PU-08-005

Product Update Hendrickson Height Control Valve (HCV) Kits

PRODUCT UPDATE Height Control Valve (HCV) Kits

LIT NO: P56035

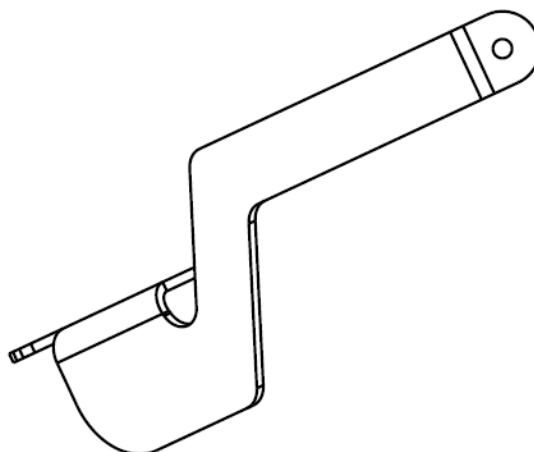
Hendrickson Trailer Commercial Vehicle Systems announces a change to height control valve (HCV) kits used with AAL suspensions featuring the Large-Diameter Axle (LDA™). The lower mounting bracket has been modified to provide an optimized solution for both drum brake- and air disc brake-equipped suspensions. As shown below, the mounting hole locations remain the same, and therefore the attachment method is unchanged. The shape of the bracket has simply been revised.

**Current Lower
Mounting Bracket
(VS-31075)**

**New Lower
Mounting Bracket
(VS-37016-1)**

The following HCV kits will include the new lower mounting bracket, effective with orders shipped on or after February 29th, 2016. The new bracket, VS-37016-1, will replace the current bracket, VS-31075, in the aftermarket.
